# Addendum # 1

**Project Name:** Sheepdraw Trails Connection

**Bid Number:** F24-10-084

**Date:** October 21, 2024

**CITY OF GREELEY, COLORADO**  
**GREELEY, COLORADO**  
**SHEEP DRAW TRAIL CONNECTION PROJECT**  
**EROSION & SEDIMENT CONTROL**

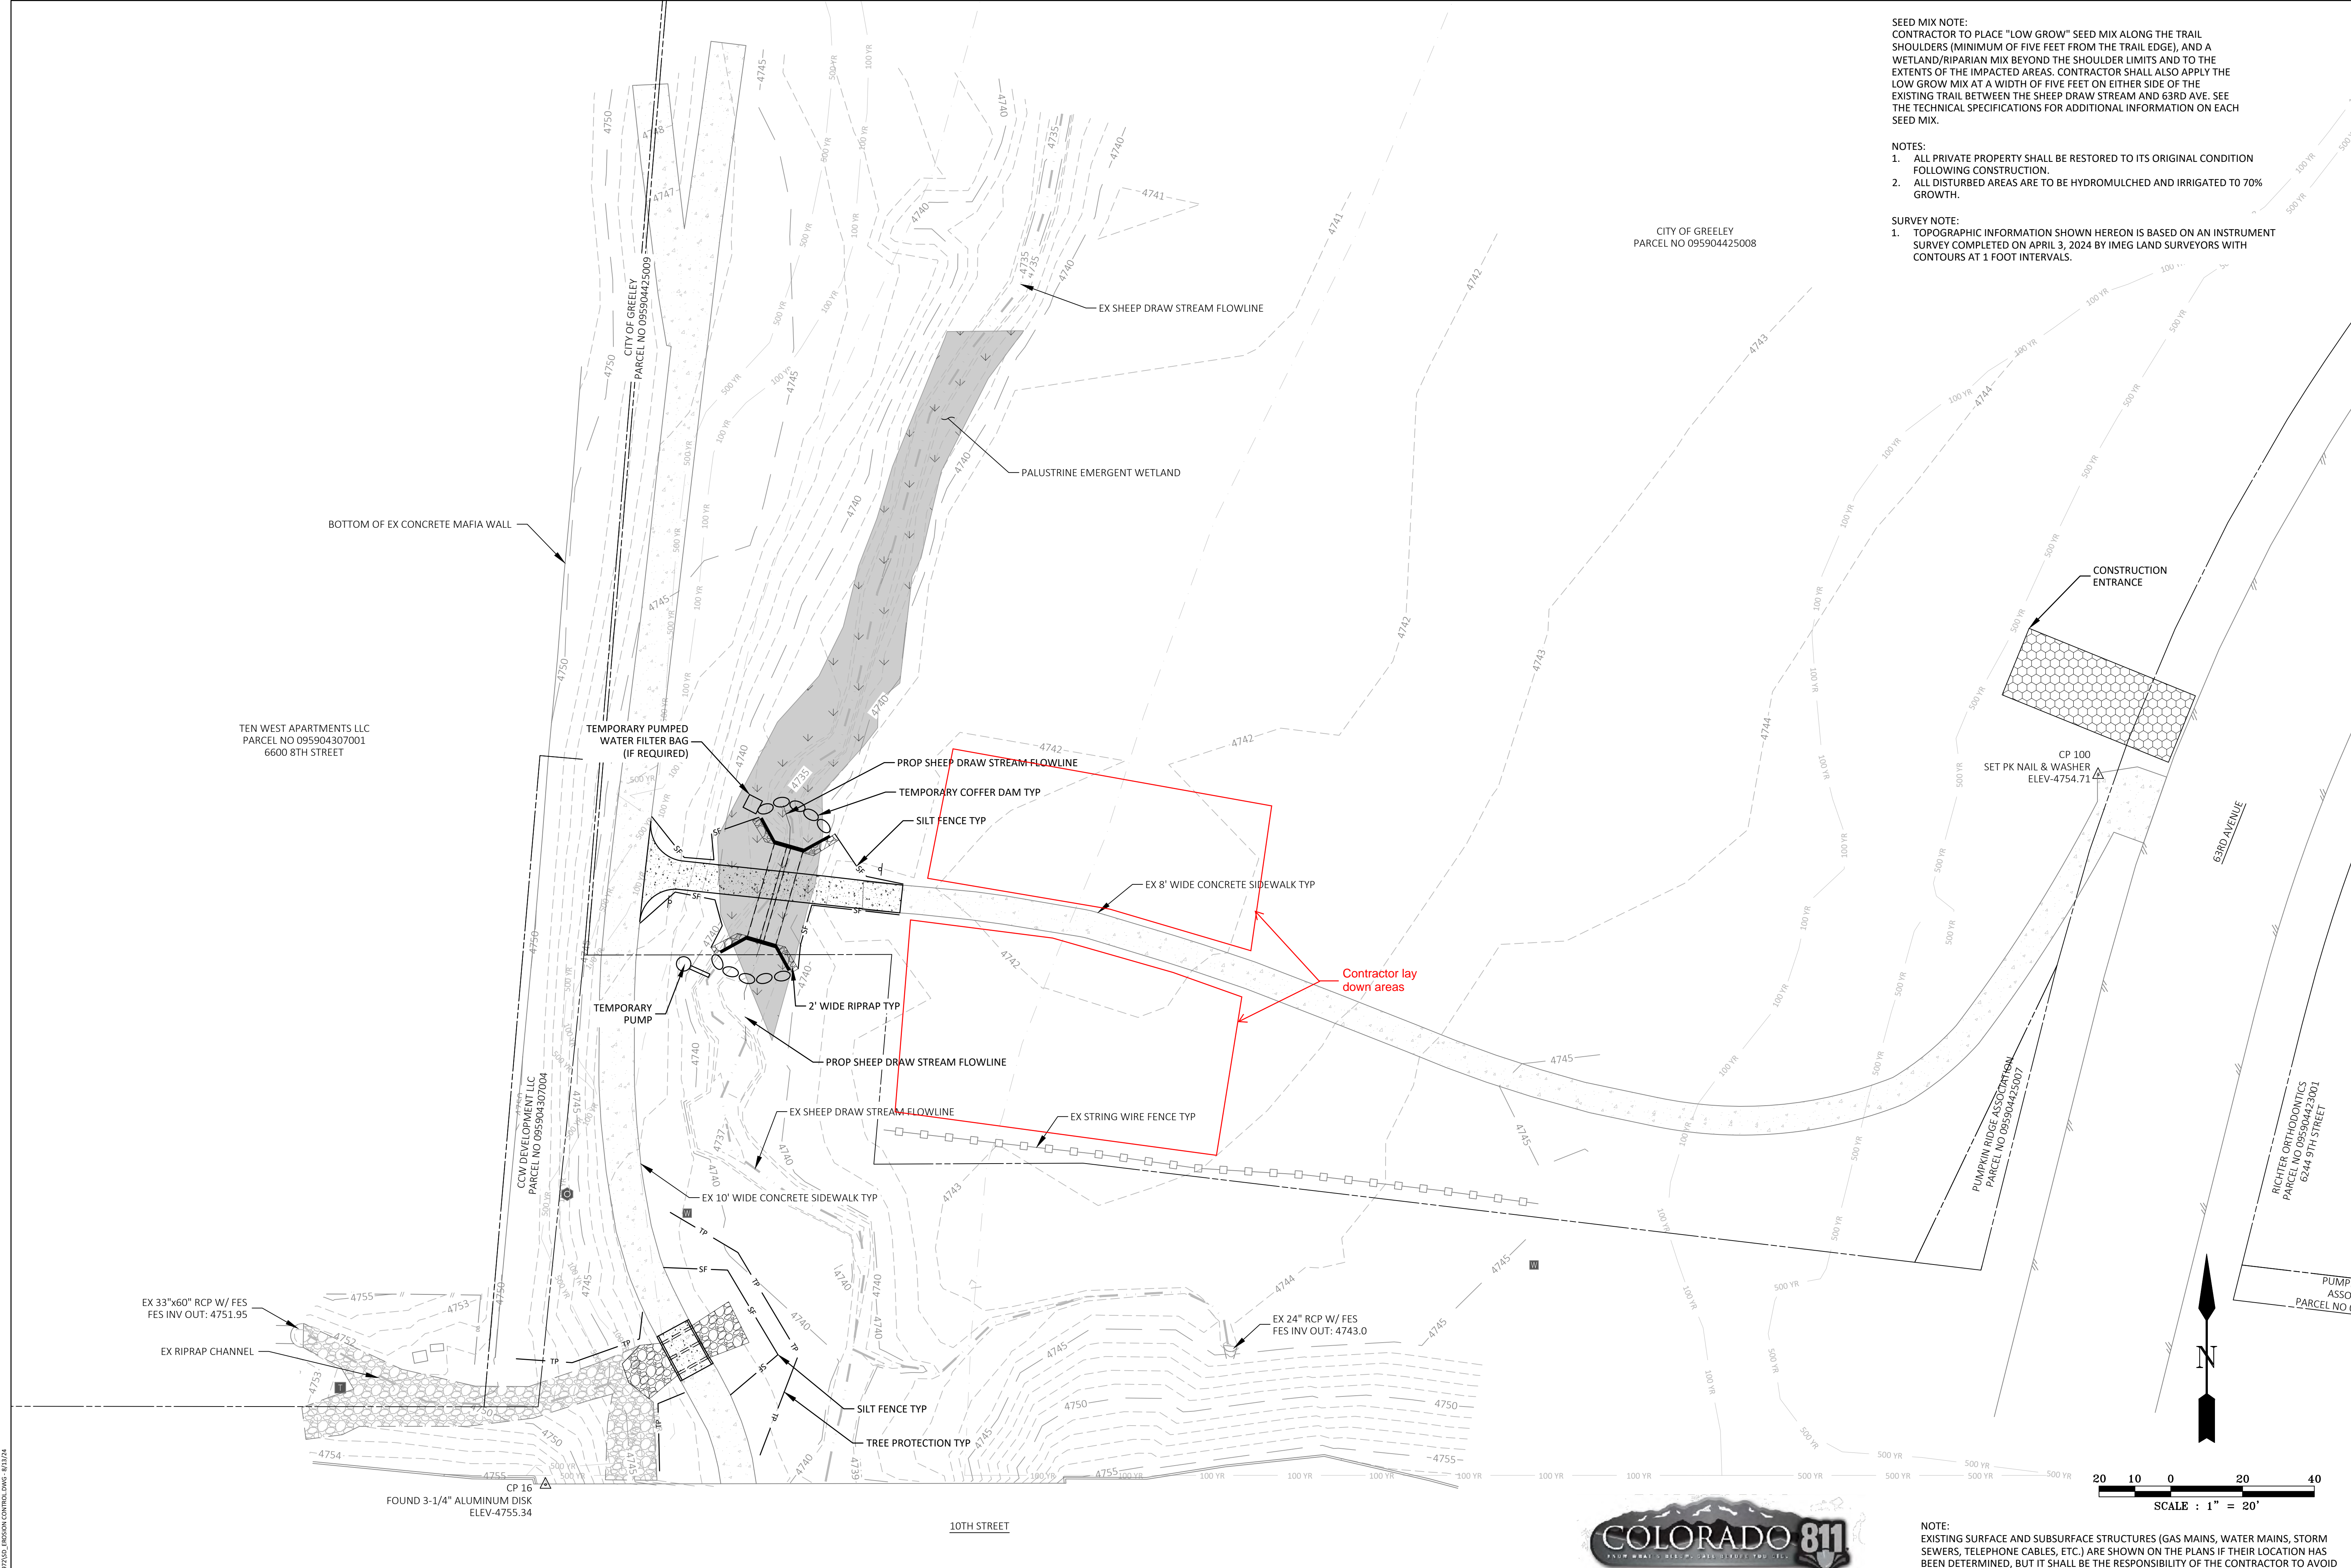
**Question #1** Where is the laydown/staging area for this job to be located at?

**Answer** Laydown/staging will be located on the east side of the sheep draw in proximity to the existing trail area. See attached redlined plan sheet.
